MANDATORY SERVICE BULLETIN

No. 2182
ATA Code 27-40
Recurring Inspection

SUBJECT: FLIGHT CONTROLS - INSPECTION OF STABILATOR HINGE
BRACKETS FOR WORKING RIVETS

INSPECT ALL STABILATOR HINGE RIVETS FOR CONDITION AND SECURITY
Figure 1

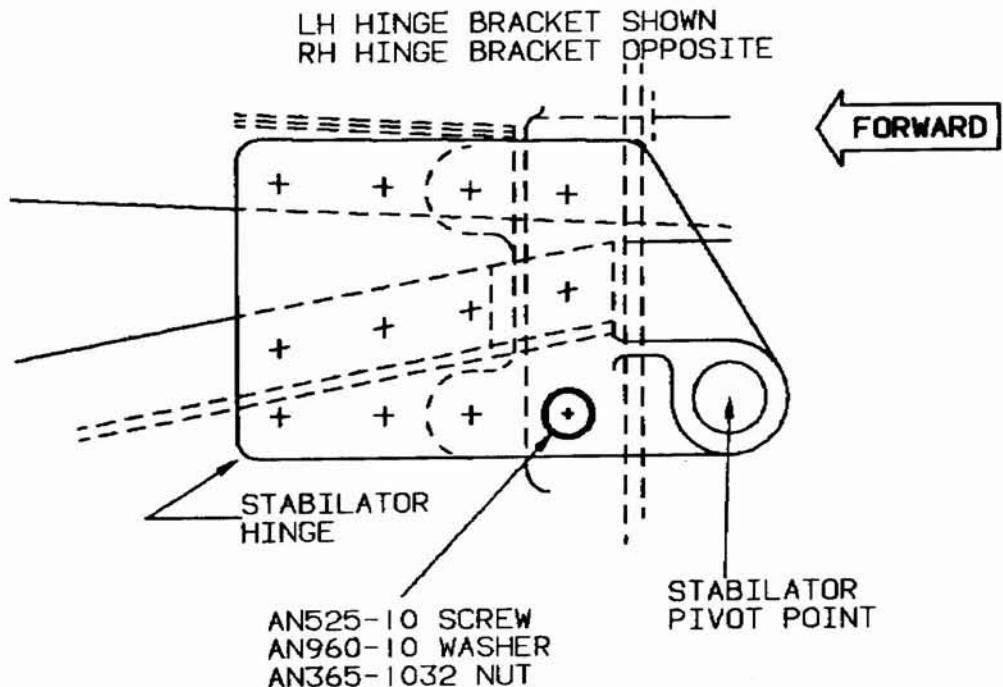
1. Refer to Figure 1 and visually inspect both the LH and RH stabilator hinges, at the fuselage attach point, for broken, loose or working rivets as follows:
 - a. Inspect for cracks in paint around the circumference of a rivet head.
 - b. Inspect for black discoloration which appears as residue working out from beneath the rivet head.
 - c. Inspect for any gap between the rivet head and airplane skin.
2. If none of the above conditions exist and the LH and RH stabilator hinges appear to be in a normal and secure configuration, no further action is necessary at this time.
3. If any rivet on either the LH or RH stabilator hinges is found to be working, all rivets on both hinges must be replaced with P/N MS20470AD-5 or -4 (as appropriate) rivets of the appropriate length for material thickness.

Replace the rivets in horizontal rows (one row at a time) to maintain stabilator hinge/fuselage alignment. See illustration.

5. If an oversize fastener is required, enlarge the hole as required to accept a P/N CR2249-5 or -4 (as appropriate) Cherrylock rivet (NAS1738-5) of the appropriate length for material thickness.
6. If rivet replacement has been accomplished, replace the existing screws, washers and nuts on both the LH and RH stabilator hinges with new P/N AN525-10 screws, new P/N AN960-10 washers and new P/N AN365-1032 nuts.
7. If problems are encountered during the rivet replacement procedure, contact: Beech Aircraft Corporation Commercial Service Department, Phone (316) 681-7265, International TELEX No. 203603.
8. Refer to the Maintenance Manual and reinstall the stabilator.
9. Reinspect the LH and RH stabilator hinges as described in a, b and c above at each 100 service hour interval (normal category) or each 25 service hour interval (acrobatic category) until further notice.
